# UNITED STATES PATENT AND TRADEMARK OFFICE

10/019,558

<b>Office Action Summary</b>	<b>Application No.</b> 10/019,558	<b>Applicant(s)</b> GUATA, HAIM	
	<b>Examiner</b> THIERRY L. PHAM	<b>Art Unit</b> 2625

### **DETAILED ACTION**

FIG. 2

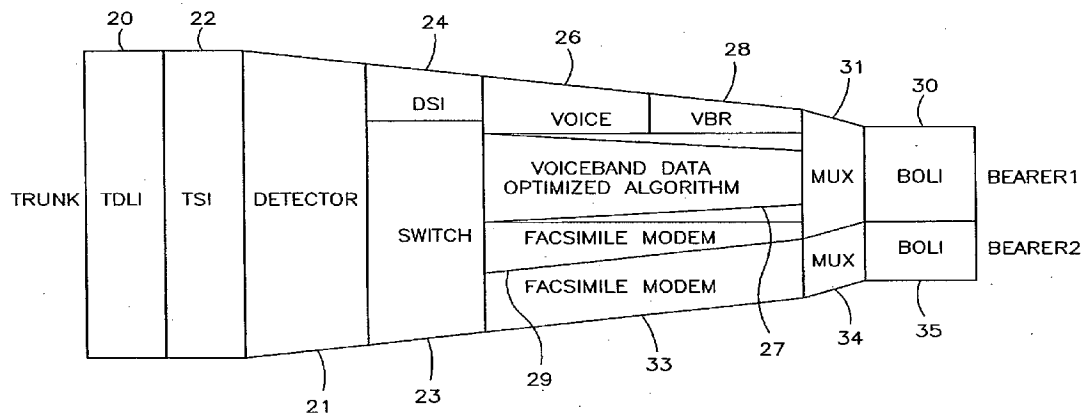
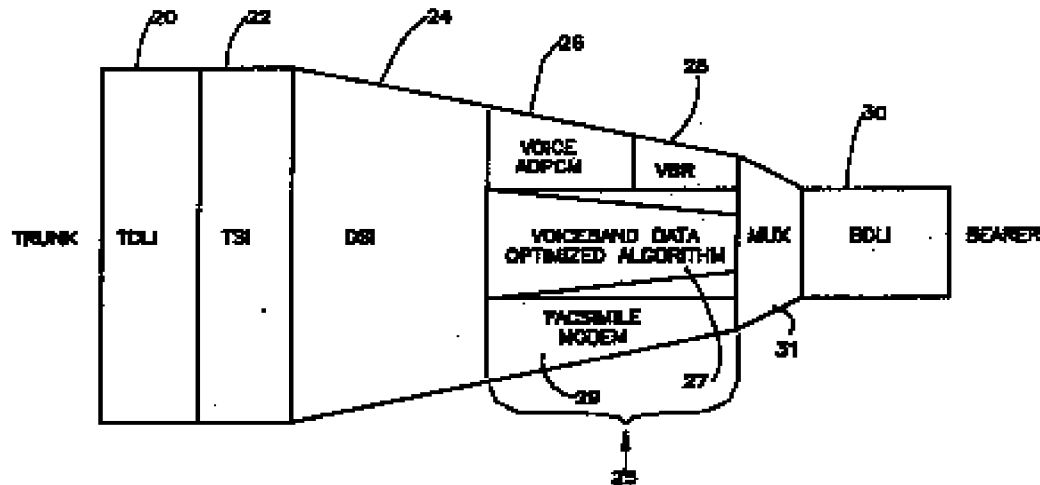
In response, the examiner herein disagrees. Fig. 2 shows (applicant's filed specification) a detailed configuration of a digital telecommunication station (see fig. 2 below) having two transmission paths (e.g. BEARER 1 and BEARER2) along with bearer interfaces 35. A telecommunication station further includes multiplexers 34 and facsimile modems 29.

Fig. 1 of the cited prior art of record (US 5117453 to Piasecki et al) shows a detailed configuration of a digital telecommunication station (see figure below) having a transmission path BEARER with interface 30 along with multiplexer 31 and facsimile modem 29. Fig. 1 of Piasecki only shows a one transmission path, one multiplexer, and one facsimile modem.

Furthermore, digital telecommunication station as taught by Piasecki includes a detector DSI 24 for detecting plurality of different types of signals (e.g. voice and facsimile data, see col. 2, lines 20-63 and col. 5, lines 25-30, fig. 1). Piasecki does not expressly teach wherein each type of signal is associated with a different class of quality of service. An example of quality of service of each type of signal is disclosed in page 20, lines 17-22 of applicant's original specification "for example, when videos signals are received as data they may be treated differently (to have higher quality) then data signals that are transmitted in email transmissions. In such a case the email data signals will be diverted from the first transmission path and the video transmission will be carried out at higher quality". It is obvious and well known that facsimile data and voice data as taught by Piasecki have different quality of service based upon their type of signals. The examiner herein relied upon Jarvinen for the teaching of such well known of an association of each signal with a different class of quality of service (telecommunication device that includes a detector for detecting different types of signals and to classify signals into different classes based upon signals quality of services, fig. 7, col. 2, lines 57-65 and col. 3, lines 10-30, fig. 6). Neither Piasecki nor Jarvinen suggest a wherein each type of signal (wherein each signal is having different quality of service) is routed to a separate transmission path. The examiner herein relied upon Ovadia for such teachings of a

telecommunication device having plurality of transmission paths (transmission path 22 & 14, fig. 1) and to divert (divert signals using multiplexer 10, fig. 1) signals to an appropriate transmission path (col. 1, lines 60-67 and col. 9, lines 1-25). Therefore, it would have been obvious to add an additional transmission path (BEARER 2) so that voice data is routed to one transmission path, wherein facsimile data is routed to another transmission path to prevent data interference. Furthermore, it would have been also obvious to add an additional transmission path to an existing telecommunication station as taught by Piasecki so is to provide an improved data multiplexer capable from among of a plurality of band communication rates dependent upon the quality of the communication channel (col. 1, lines 65 to col. 2, lines 4). The combined teachings of Piasecki and Jarvinen with Ovadia allows the telecommunication device to route data in a temporary basis or permanent basis (for example, all facsimile data will be permanently routed to first transmission path BEARER 1, wherein voice data will be permanently routed to second transmission path BEARER 2).
